# ADA Self Evaluation and Transition Plan

MiraCosta College, San Elijo Campus

09-07-2016

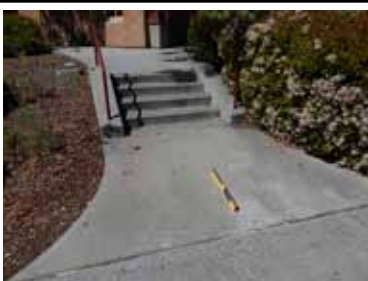
C1	<p>The stairway is not compliant as follows:</p> <ol style="list-style-type: none"> <li>1. There are no contrasting color warning stripes on each nosing for the visually impaired.</li> </ol>		<ol style="list-style-type: none"> <li>1. Provide contrasting color warning stripes at each nosing according to Appendix C.4</li> </ol>	P2
----	--	--	---	----

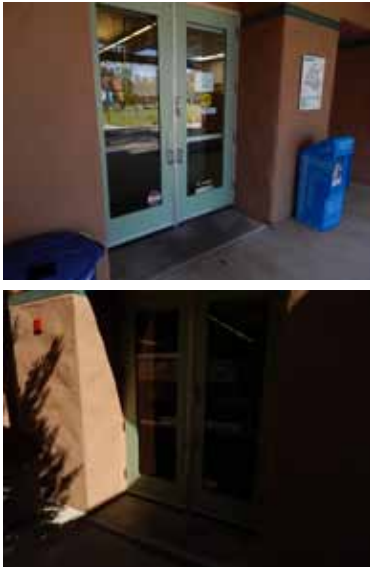
D6.13	The accessible lavatory is not compliant as follows: 1. The faucet exceeds 5 pounds pressure to push and does not flow for at least 10 seconds.		1. Modify the faucet pressure to be less than less than 5 pounds and flow duration to be at least 10 seconds. (The mirror above the lav is at 44" ht.; however, a compliant wall mirror exists in the room).	P1
D6.14	The accessible toilet and stall is compliant.		None required.	N/A
D6.15	The accessible ambulatory toilet stall not compliant as follows: 1. The compartment door is not self-closing.		1. Adjust the door to be self-closing.	P1
